ISSUE: Certificate of Appropriateness for new construction

APPLICANT: City of Alexandria and Washington Metropolitan Area Transit Authority (WMATA)

BAR#2019-00241
2901 Potomac Ave. (2405, 2501, and 3701 Potomac Ave., 3251 Potomac Ave.
[Parcel ID 016.04-01-01], 700 Carpenter Rd, 1702 & 1880 Potomac Greens Dr.)

**Contract No. FQ16146 - Washington Metropolitan Area Transit Authority
(WMATA) Potomac Yards Metrorail Station
LTR-0104-PM-City of Alexandria January 22nd, 2020 BAR Submission**

2 SECTION AT 449+00
1" = 20'-0"

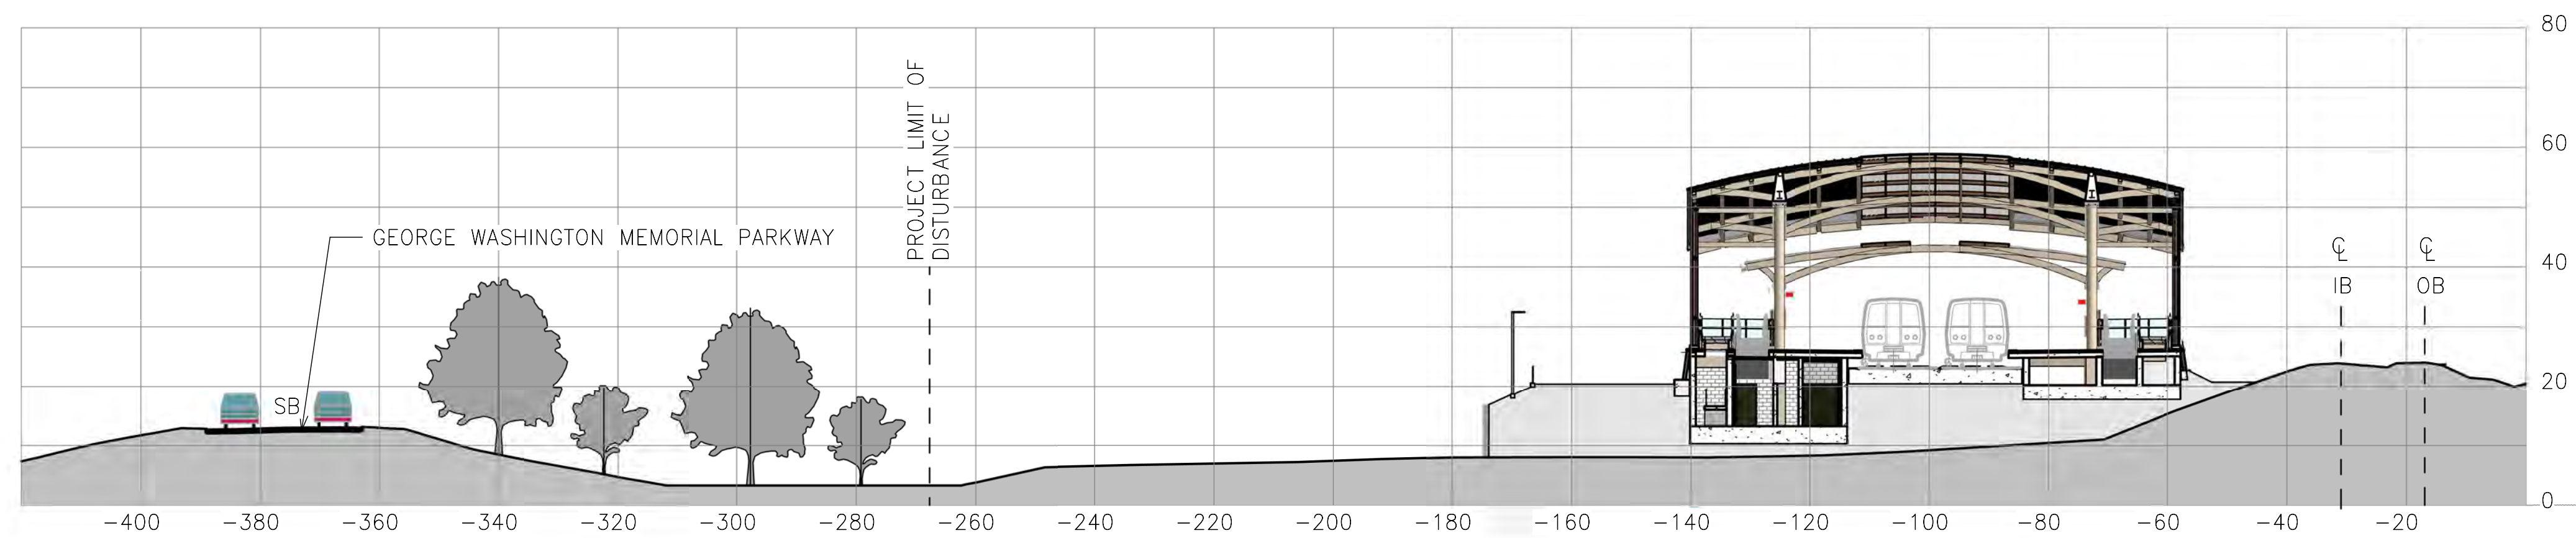
As noted above, the retaining wall design has changed as a result of extensive conversations with the National Park Service. Their landscape architects did not believe that the steep earth slope previously proposed would support native plants and would be an unsightly backdrop to the wetlands. Therefore, a vertical concrete retaining wall clad with fieldstone to match the plinth of the Metro station and historic GW Parkway infrastructure is being proposed. The height of the wall varies depending on the adjacent topography and there is an approximately four-foot wide earth berm at the top of the wall that will support plant material and contain the bases for the pole lights for the service road. Staff believes that the stone retaining wall is a far better solution than the earth berm and, although much of it will be hidden by the plant material in the wetland, it will be more attractive from the Parkway. It is also a safer edge condition for bicyclists and pedestrians on the station service road.

1. Approval of the downspout details with the color of the downspouts to match the adjacent structural feature and final review of the cover plate details by staff; the Chocolate Brown Met color flat exoskeleton finish; and the guardrail and stone retaining wall, as submitted.
2. Deferral of the cast stone details and west elevation of the entrance pavilion on the west side of the tracks, the glass handrail/guardrail details in the station and exoskeleton connection details.
